UNITED STATES PATENT AND TRADEMARK OFFICE

APPLICATION NO.	FILING DATE	FIRST NAMED INVENTOR	ATTORNEY DOCKET NO.	CONFIRMATION NO.
10/695,806	10/30/2003	Dale A. Trsar	66396-093	6880
7590 06/20/2005				
McDERMOTT, WILL & EMERY 600 13th Street, N.W. Washington, DC 20005-3096				
			EXAMINER ASSOUAD, PATRICK J	
			ART UNIT 2857	PAPER NUMBER
DATE MAILED: 06/20/2005

Office Action Summary

DETAILED ACTION

Fig. 2.

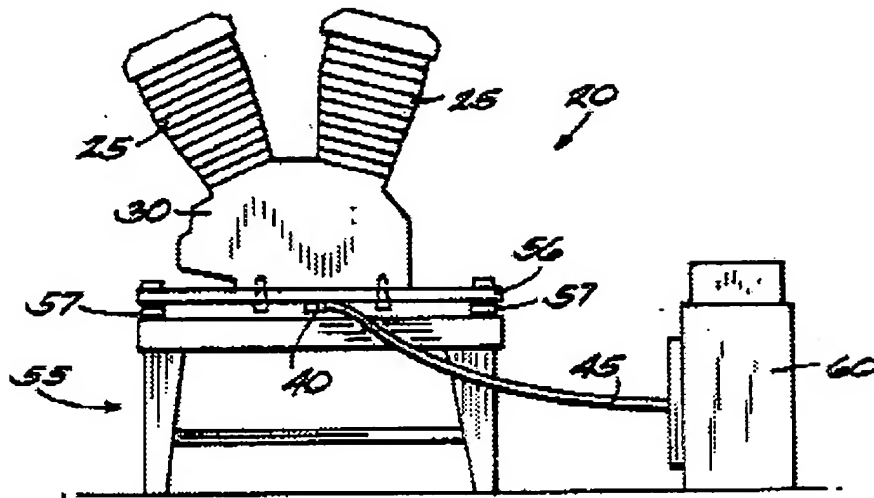
5. Applicant is referred to at least Fig. 2 of Liang et al. (reproduced below) and to the following paragraphs from Liang et al.:

6. First, the sensor 40 of Liang et al. may be directly associated with the displacement measurement sensor of Applicant. Second, engine blocks of automobiles like in Applicant's Fig. 1 are nearly always attached to the bodies of automobiles with rubber mounts (not shown by Applicant) much like the rubber isolators 57 of Liang et al. Thus, Applicant's body-side mount 125 connected to cowl 130 is directly associated with the test stand 55 of Liang et al. The test stand 55 of Liang et al. is a fixed or stationary structure in the same way that the body-side mount 125 of Applicant's Fig. 1 is fixed or stationary; i.e. fixed or stationary via rubber mounts or rubber isolators connected between the engine block and the automobile body. Therefore, the sensor 40 of Liang et al. clearly measures the claimed displacement of the engine cylinder block movement relative to a stationary structure or relative to a fixed position.

Fig. 4

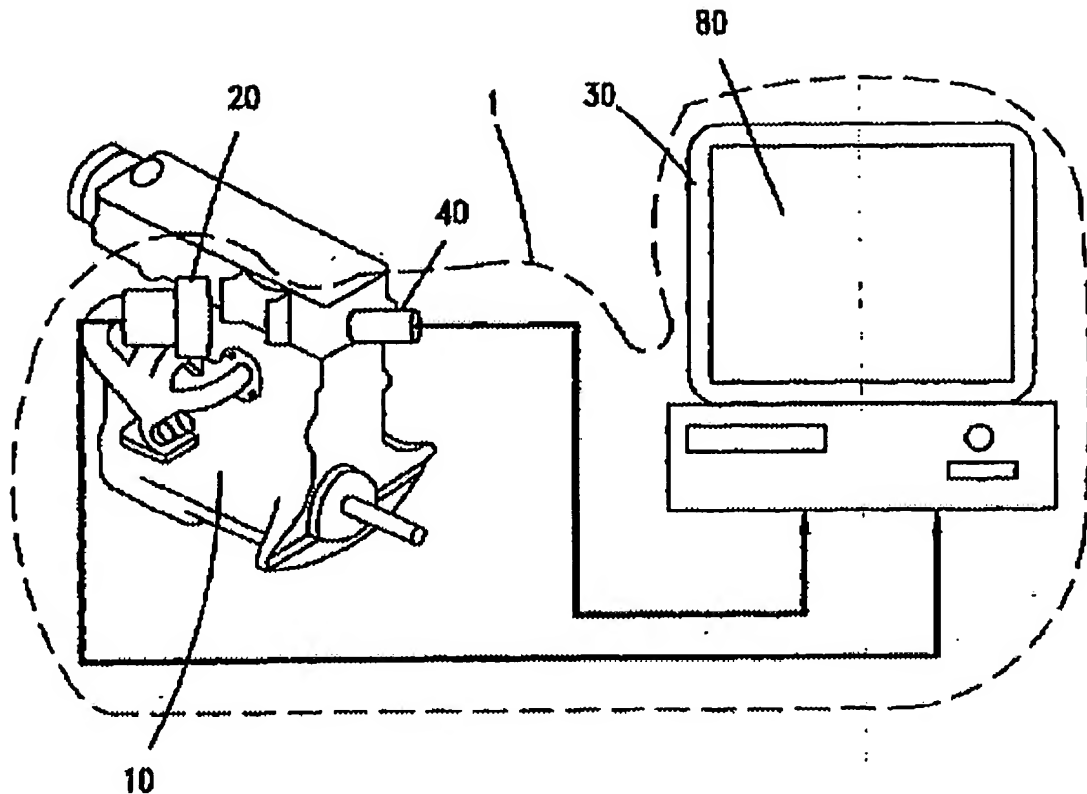
11. The association between the instant claimed invention (independent claims 1,17, and 27) and DeBotton et al. is as follows: as per the claimed displacement measurement device or means for monitoring engine block movement, see the vibration sensor (20) mounted to the engine block (10) of Fig. 4 of DeBotton et al.; as per the claimed signal analyzer or means...for evaluating engine block movement, see the computer (30) of Fig. 4; as per the evaluation of engine cylinder contribution or evaluation of engine block movement, see at least the FFT vibration processing, vibration signature analysis, reference data base construction and comparison

12. Note that vibration is a known function of displacement/acceleration of engine block (10) and that the vibration sensor (20) of DeBotton et al. may be a "transducer such as an accelerometer, velocity transducer, optical or laser based vibration transducer...being held in place with any suitable, temporary fixing means such as magnets or straps..." (para. 0142)

Fig. 2.

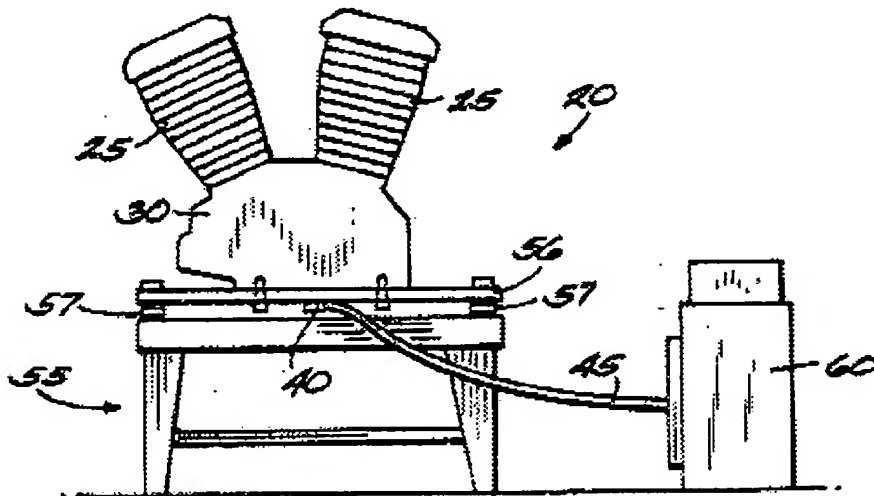
16. From Fig. 2 (above) and its description, we clearly see vibration (acceleration/displacement) measurements “relative to a stationary structure” which is the test bed 56 and/or test stand 55 of Liang et al.

17. Thus, it would have been obvious to one having ordinary skill in the art at the time the invention was made to combine the “detection of engine block movement relative to a stationary structure” teaching of Liang et al. with the “universal diagnostic method and system for engines” of DeBotton et al. because such a combination provides accurate and reliable (vibration/acceleration/displacement) measurements for diagnostic purposes, and for fine-tuning an engine by accurately balancing all cylinder contributions relative to a fixed position or stationary structure.
